THE GLIDING FEDERATION OF AUSTRALIA

GFA AD 415
(ISSUE 1)

GFA AIRWORTHINESS DIRECTIVE

Schempp-Hirth Flugzeugbau GmbH Kramersstraße 25 - Postfach 14 43 D-7312 Kirchheim unter Teck LBA-Nr. 1 B 5	TECHNICAL NOTE NO. 278 - 33 286 - 28 293 - 22 328 - 10 349 - 16 360 - 9 373 - 5	S/N Page No. No. of pages																																										
Subject : Vertical elevator actuating rod inside the fin																																												
Affected :

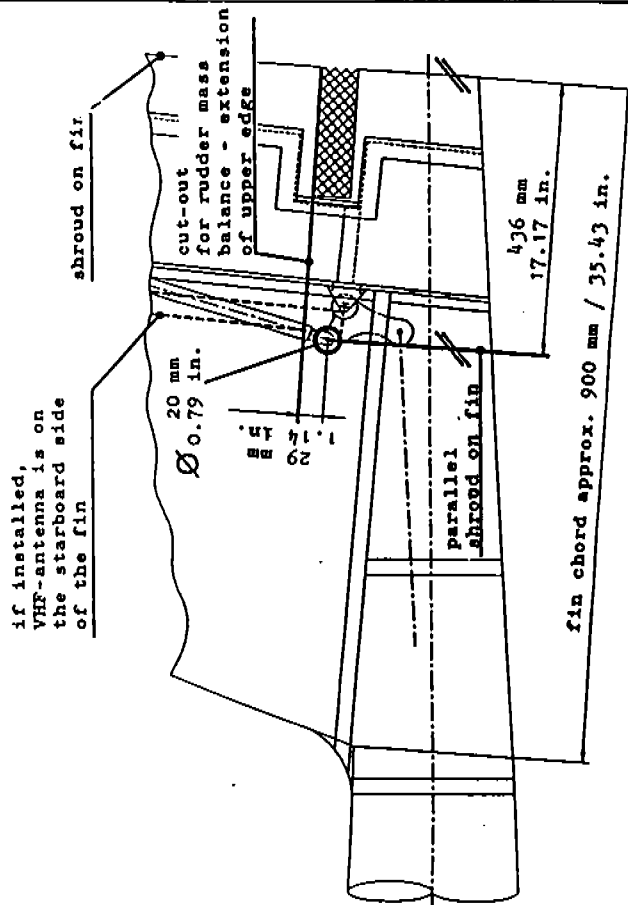
- Drill a small hole (ϕ 6 mm/0.24 in.) through the skin of the fin on its port side as shown in the sketch on page 3 through 7. Check opening for proper alignment with the bolt to be removed and make sure that the VHF-antenna (if installed) will not be damaged when repeating the step on the far side - then enlarge opening appropriately to a diameter of 20 mm/0.79 in. - Repeat procedure on the starboard side - be careful not to damage the antenna (if installed). - Prior to disconnecting the upper end of the elevator actuating rod (from elevator actuating lever), measure the length of the thread projecting above the jam nut and register value (for reinstallation). WARNING: Only ball bearing rod ends type "14C6" (or - as used on some sailplanes - U-shaped rod ends) having a thread length of 60 mm/2.36 in. are permissible! - Disconnect lower end of vertical elevator actuating rod at the base of the fin by removing the bolt "M6" with the aid of a socket wrench. <u>Recommendation:</u> - Thin adhesive tape or grease in the wrench's socket will prevent the nut or the bolt from falling down into the tail boom while pulling out the tool. - The washer can be removed with the aid of a magnet. - Using a drift facilitates the removal of the bolt. - Remove bolt attaching the vertical elevator actuating rod to the elevator actuating lever.

INSTALLING THE VERTICAL ELEVATOR ACTUATING ROD		
- Install replacement elevator actuating rod by reversing the above steps (5 through 3). - Mount horizontal tailplane and check elevator deflections - if necessary adjust ball bearing rod end (or U-shaped rod end) on actuating rod such that the deflections are within the permitted range. Make sure that the depth of the seating of the threaded rod end is at least 10 mm (0.39 in.). - Check for foreign particles in the fuselage tail boom and tape over the openings cut at the base of the fin.
